Date: NOV 16 2009
Refer To: EP2009-0604

Subject: Request for Approval of Permeable Reactive Barrier Design Modifications for Consolidated Unit 16-021(c)-99

CORRECTIVE MEASURES IMPLEMENTATION
CONSOLIDATED UNIT 16-021(c)-99

Figure 1

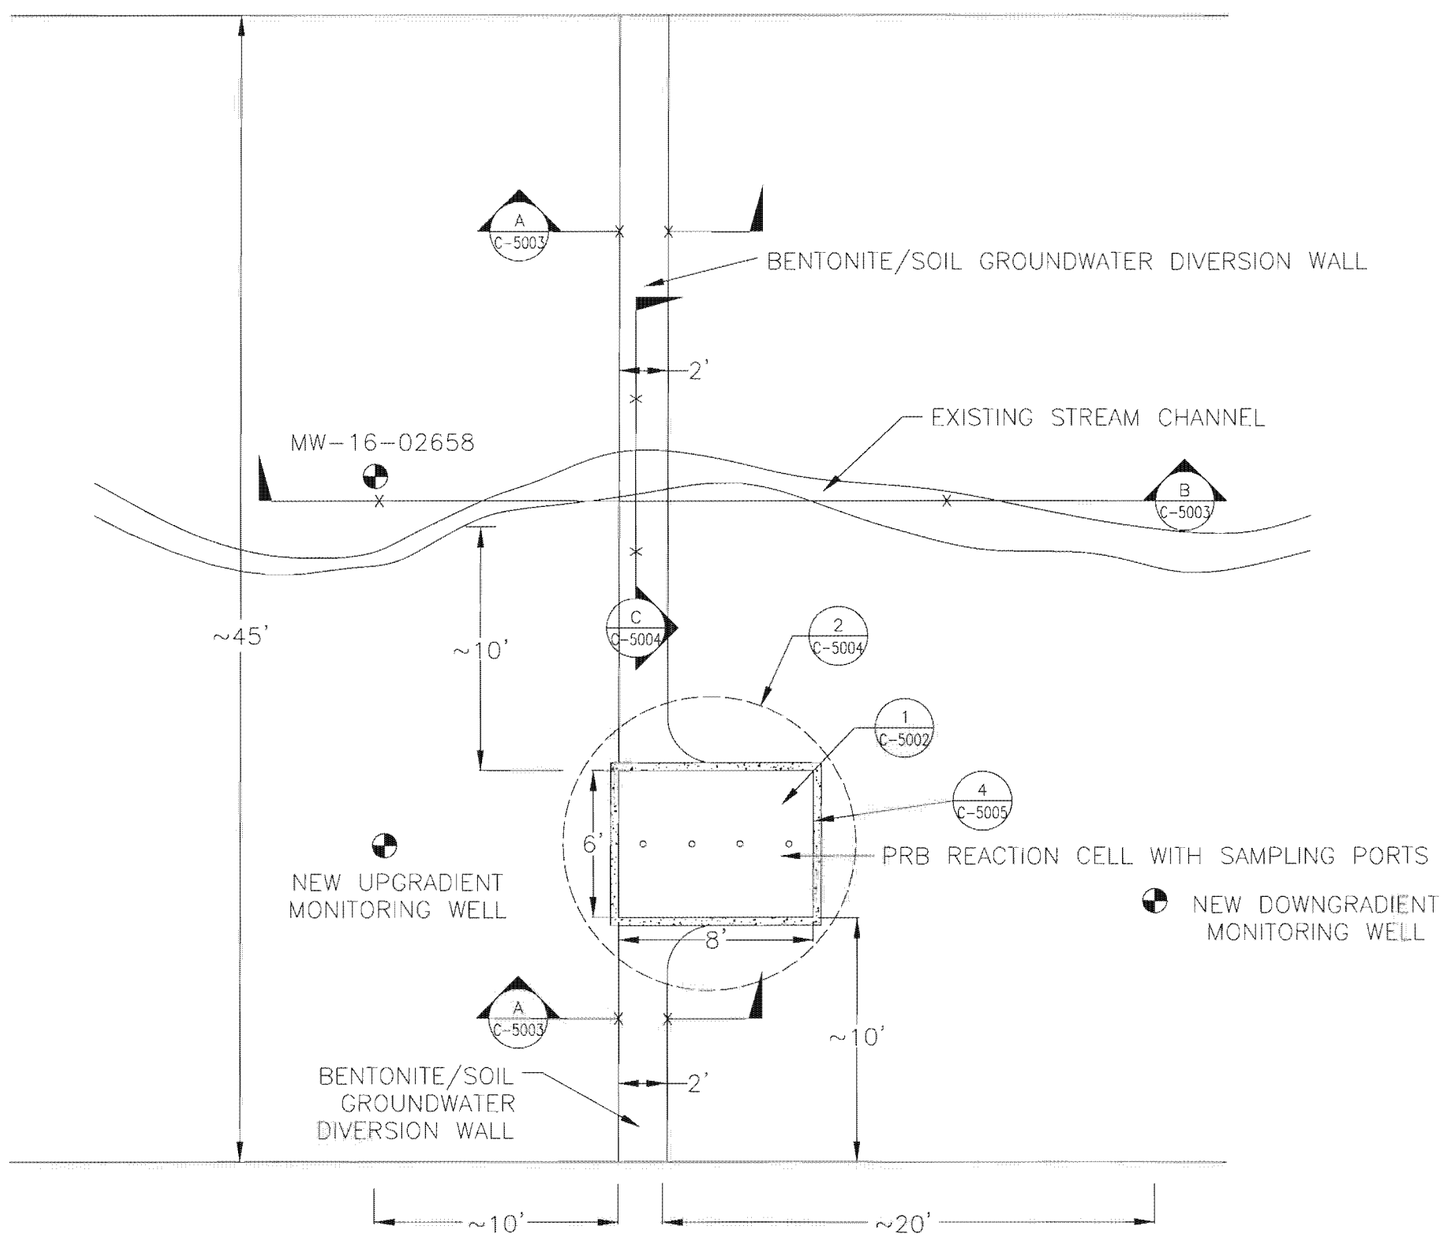
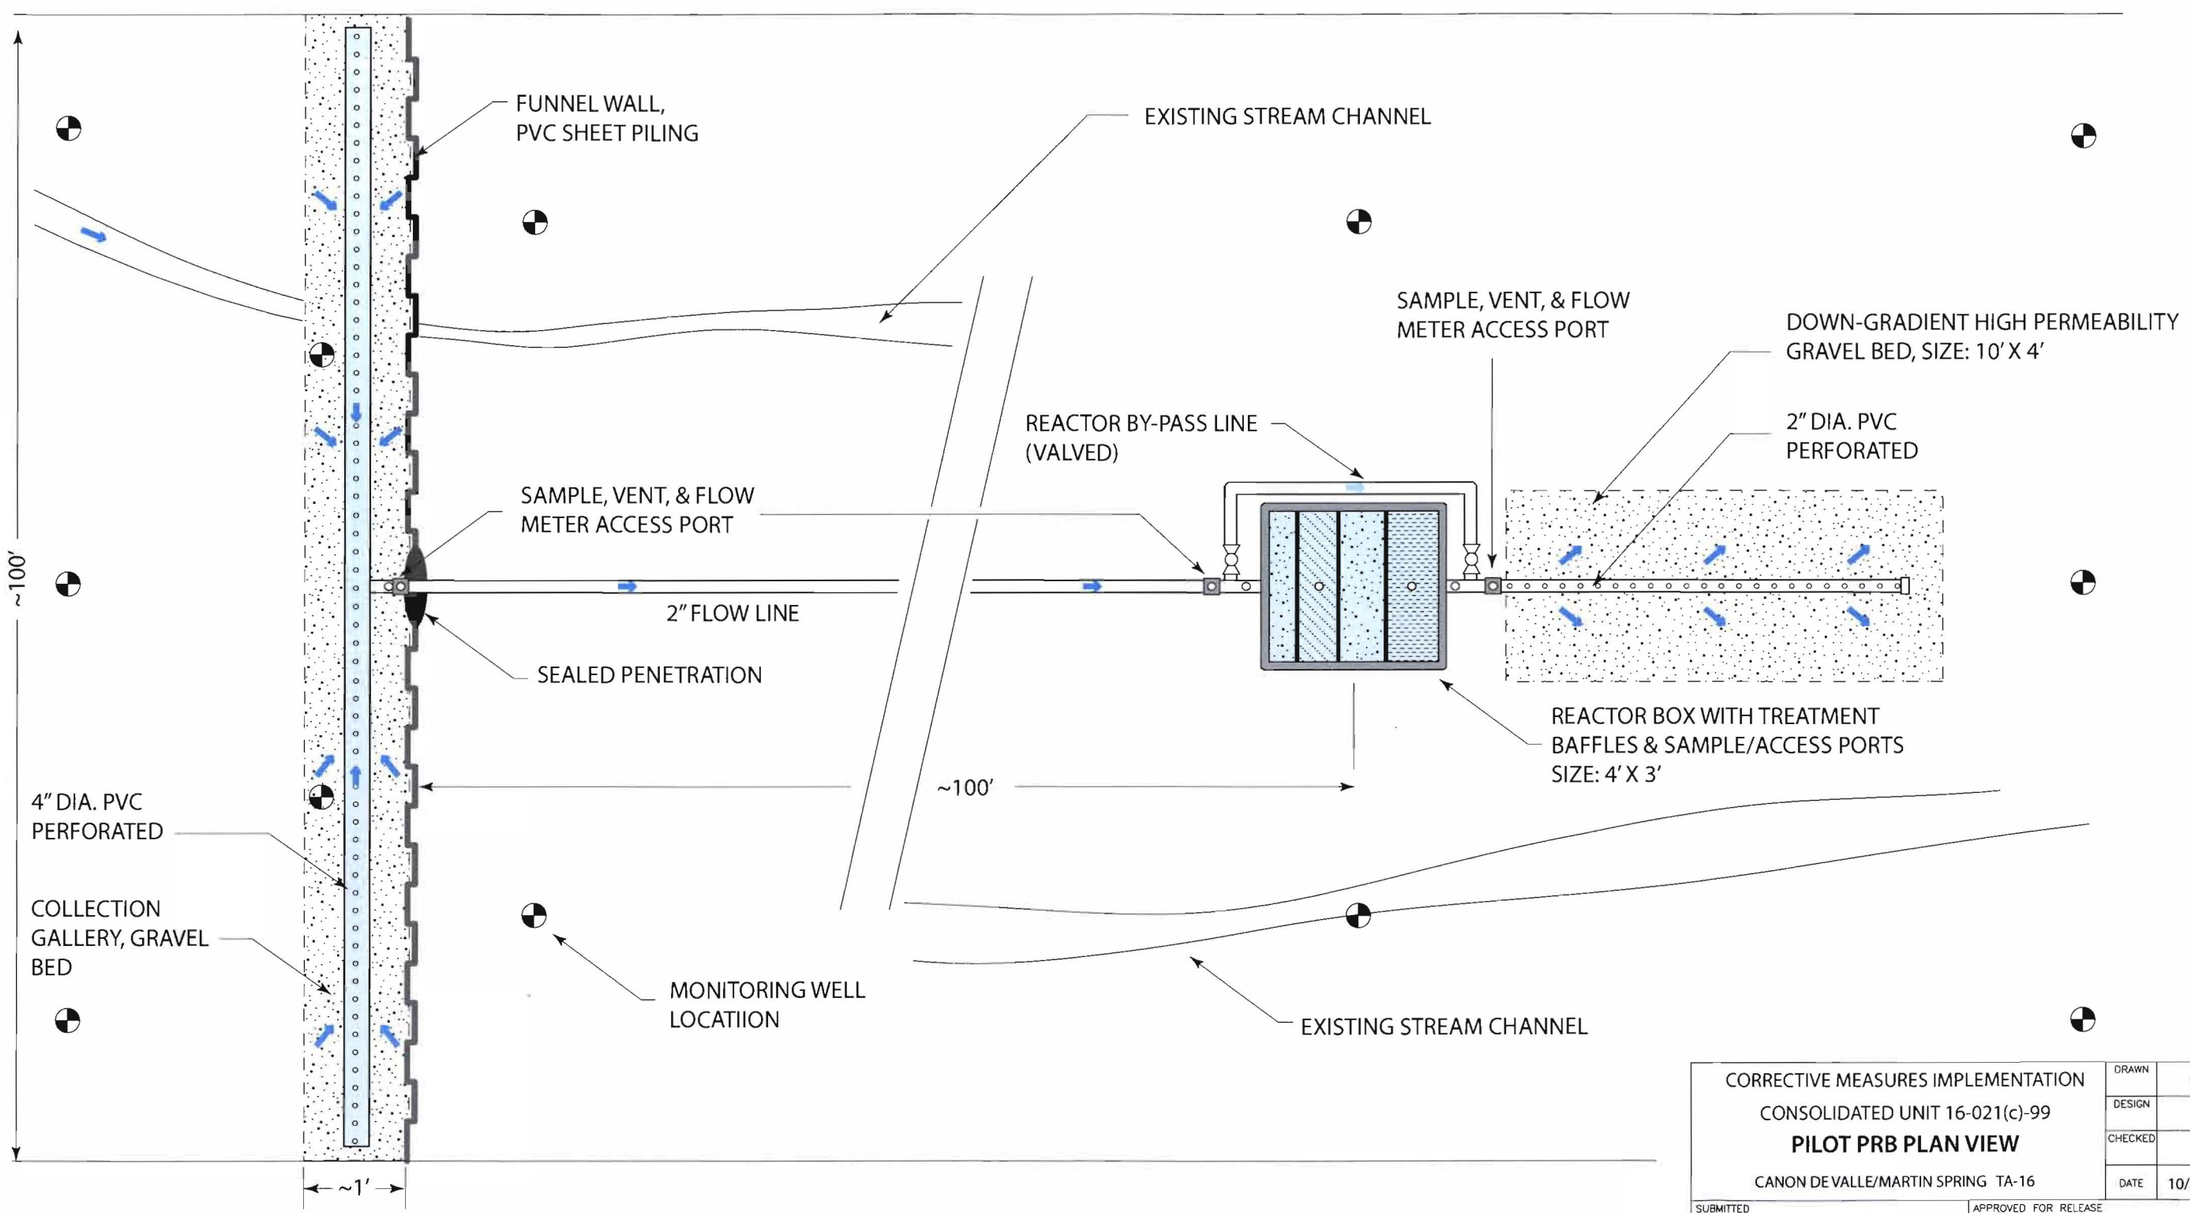
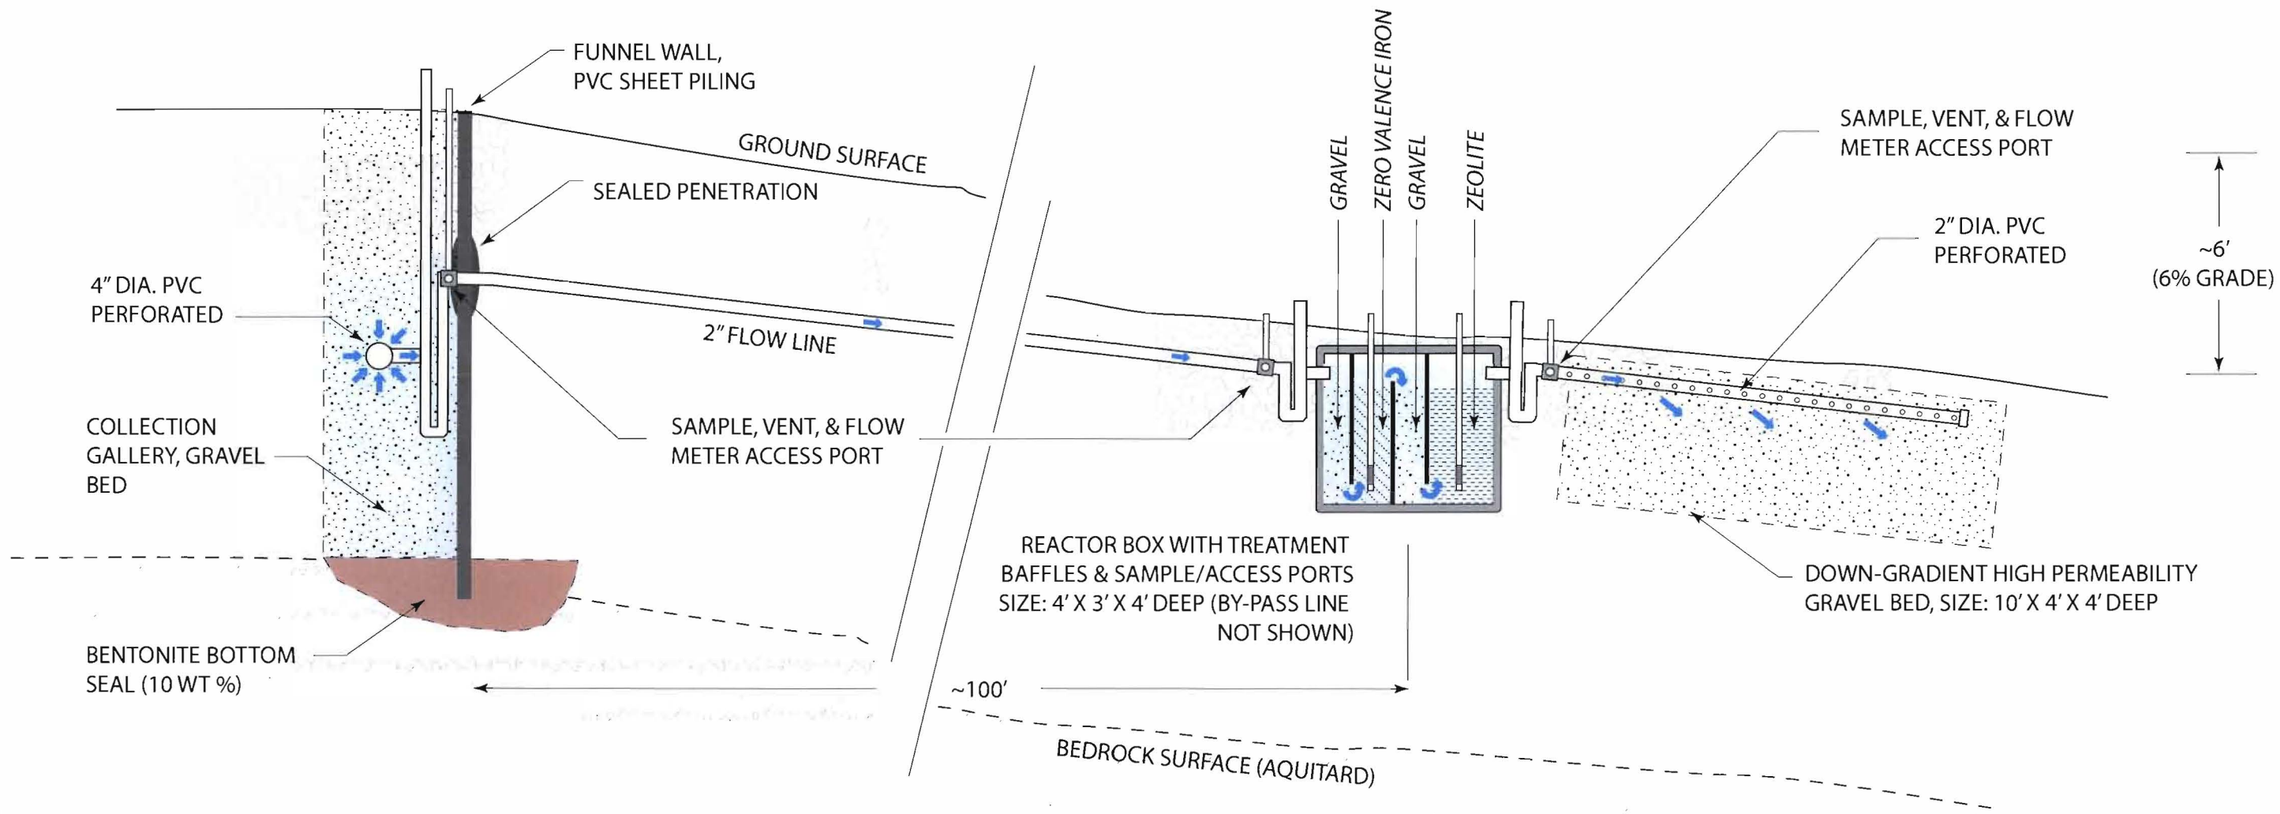
Based on results from the test pits, the Laboratory proposes several design modifications necessary to improve the performance of the original design and that were developed primarily in response to current field conditions. While in the field, it was determined the width of the canyon bottom and the depth of alluvium had been underestimated in the CMI plan. The cutoff wall will need to be approximately 100 ft long rather than 45 ft as originally proposed, and the depth of alluvium will be approximately 9 ft rather than 4 to 5 ft. The original design of the PRB was presented in the CMI plan and is attached as Figure 1.

(1) Substitution of a high-density polyethylene (HDPE) or vinyl sheet piling for the diversion wall instead of a soil/bentonite mixture wall. Plastic sheet piling will be keyed to bedrock with a bentonite seal. This PRB design modification is shown in the attached Figures 2 and 3. It should be noted that the engineered erosion controls specified for the location where the stream

(2) Offset of the PRB reactive cell downgradient of diversion wall instead of direct connection to the diversion wall (Figures 2 and 3).

(4) Addition of an infiltration gallery immediately downgradient of PRB reaction cell. A high permeable gravel bed located downgradient of the PRB vessel would be installed. The volume of the gravel bed would be similar to the volume of the PRB cell (see Figures 2 and 3).

(7) Modification of PRB reaction cell to include multiple baffles. The baffles will be anchored to the sides of the vessel and will alternately extend from the top or bottom of the vessel. This modification is depicted in the side view of the revised PRB design presented as Figures 2 and 3 of the attachment to this letter. Baffles will eliminate the potential for water to bypass the treatment media, thereby ensuring the treatment residence (contact) time is met and the media remains continuously saturated.

a. Mechanical advantage: continuous impermeable wall with water piped directly to PRB reaction cell, resulting in reduced opportunity for leakage through wall and reduced degradation or erosion of the wall.
b. Hydrological advantage: very low conductivity (1×10^{-10} cm/s).
c. Geochemical advantage: no degradation or erosion of plastic-sheet piling over time, adding confidence in long-term water cutoff performance.

a. Mechanical advantage: downgradient location of the vessel allows for increased hydraulic head without increasing the mounding depth behind the cutoff wall beyond the original design.
b. Hydrological advantage: minimizing potential for mounding will reduce the probability of alluvial water leakage downward via fractures in the tuff.
c. Geochemical advantage: increased hydraulic head will help maintain consistent flow through the reactive cell.

a. Mechanical advantage: easy pathway for water leaving the PRB reaction cell.
b. Hydrological advantage: increase in cross-sectional area at PRB outlet to prevent potential upgradient mounding of groundwater from a bottleneck at water release point; will also help maintain the designed flow rate through PRB cell.
c. Geochemical advantage: no stagnation within the cell, thereby enhancing treatment.

(3) Installation of 20 shallow monitoring wells (2-in.-diameter polyvinyl chloride [PVC] pipe). Approximately 10 wells will be installed upstream and 10 downstream of the diversion wall. The wells will be 10 ft deep with approximately 5-ft screens and will provide additional water-level and geochemical monitoring points. The preliminary additional monitoring-well locations are shown in Figure 2.

a. Mechanical advantage: perform hydraulic check of diversion wall.
b. Hydrological advantage: measure water-level elevations, determine hydraulic gradients, and interpret flow paths. This information will help determine hydraulic capture zone, providing confidence the groundwater flow is directed through PRB reaction cell.
c. Geochemical advantage: additional sampling points to monitor geochemistry, including measuring pH and oxidation-reduction potential at several locations upgradient and downgradient of the filter media and allow for sampling for high explosives and barium to assess the performance of the PRB filter media.
